# GLAST Large Area Telescope

## Tracker Subsystem

### MRB for NCR 122

### Bias Circuit Test Coupons

# Cause of the Problem

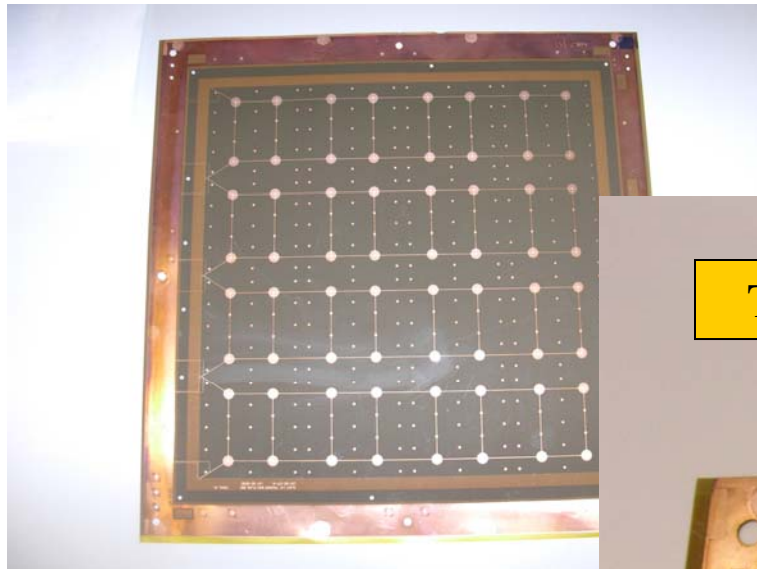
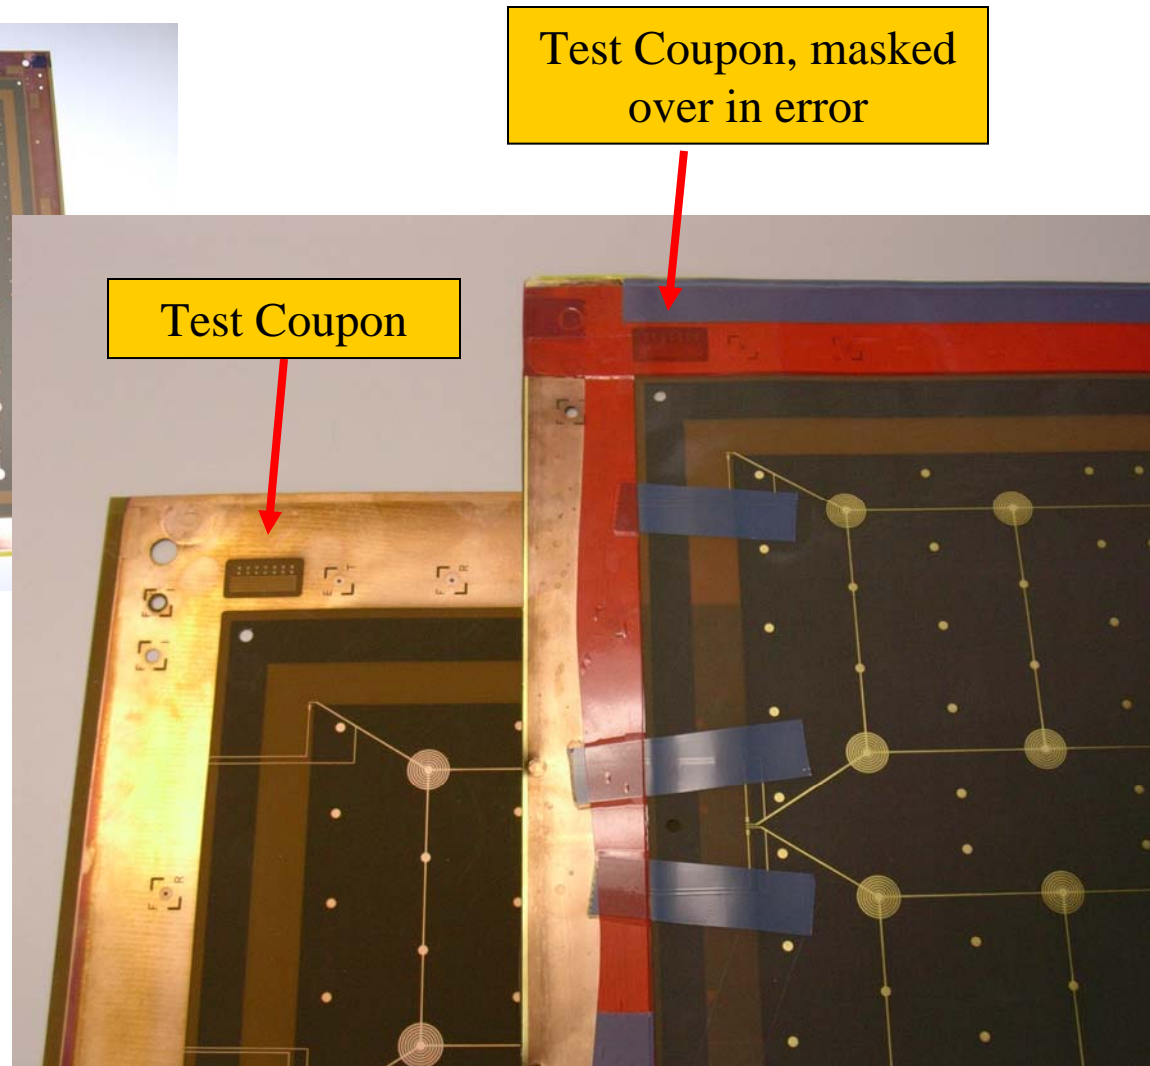
- **Root Cause**
  - **Prior to gold plating, the edges of the Bias Circuit were masked with tape; in some cases, the tape covered all or parts of the test coupons**
  - **Why: Incomplete training of masking personnel at Parlex, due to their oversight.**

# NCR 122 – Corrected Masking

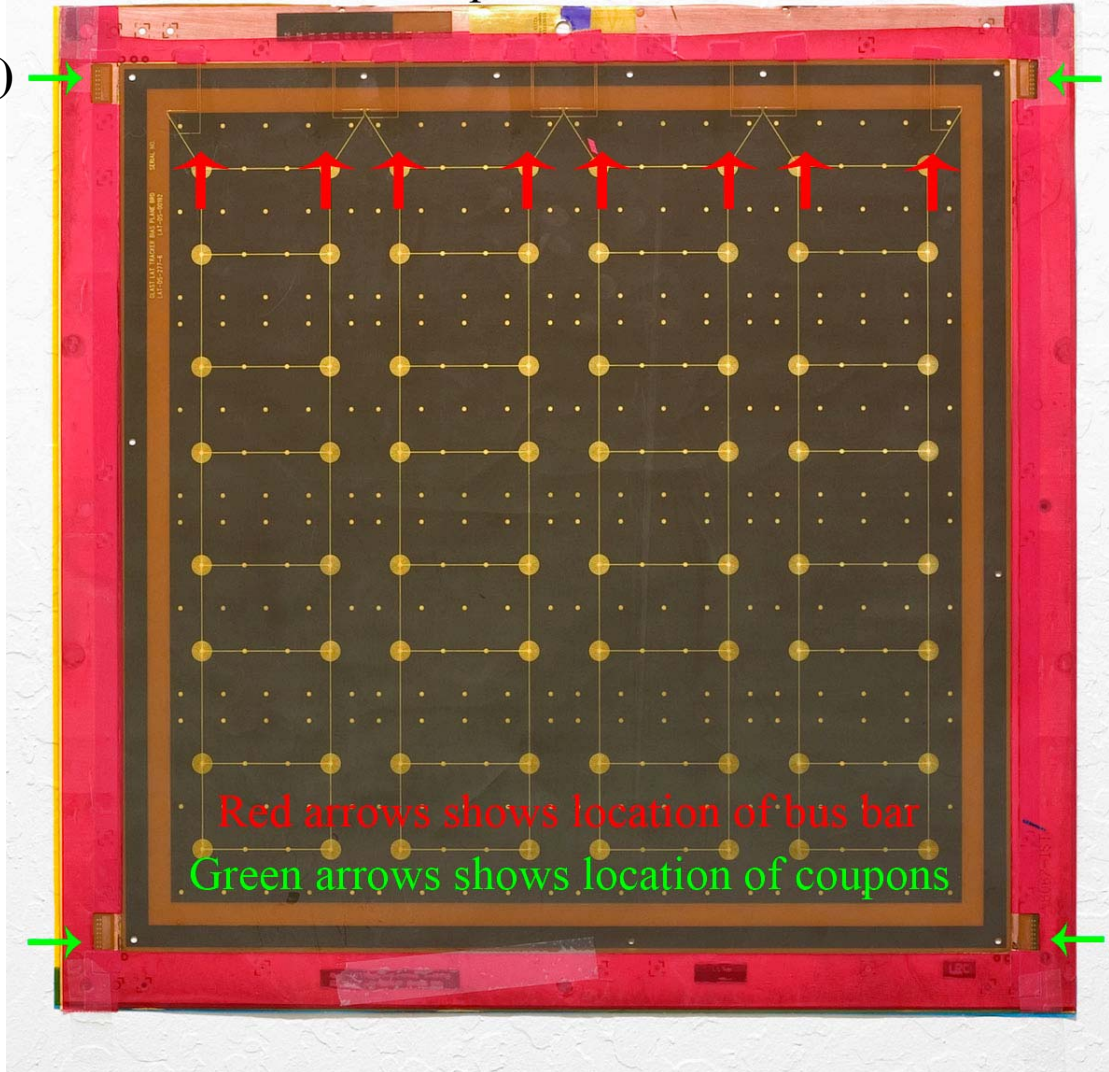
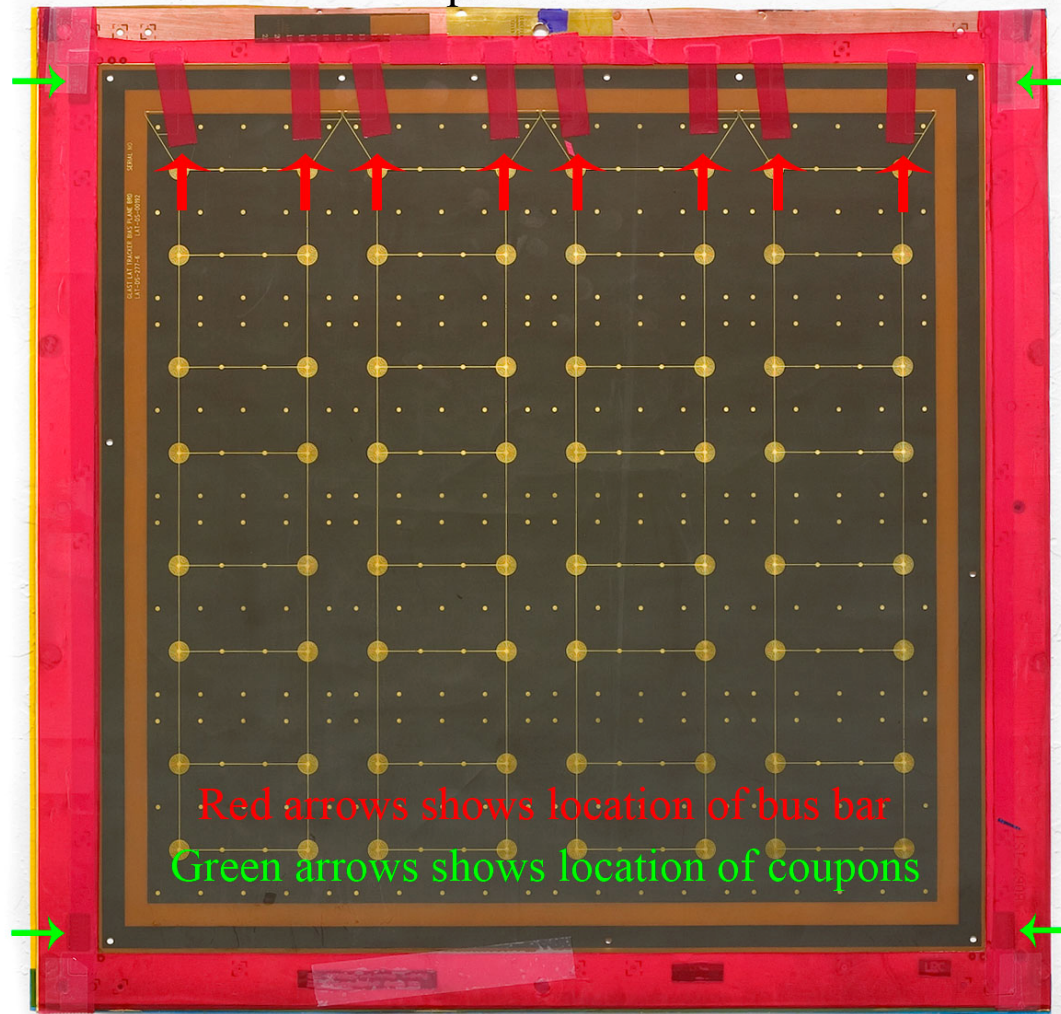
- **Corrective Action to prevent recurrence**
  - Parlex generated a manufacturing process instruction MPI-PL-0005 Rev. A for masking operation.
  - Parlex has modified the masking operation to not cover the test coupons which caused the NCR (see photo #8)
  - Rationale for masking:
    - To add rigidity during plating and etching process
    - Tie-bar etching process
    - Control manufacturing cost (GOLD!)
  - Parlex added QA inspection point to verify proper masking
  - Modified traveler to add QC inspection point to ensure proper masking
  - LAT QA to perform visual inspection of coupons for presents of gold plating

Test Coupon (4 Plcs.)

Red arrows shows location of bus bar  
Green arrows shows location of coupons
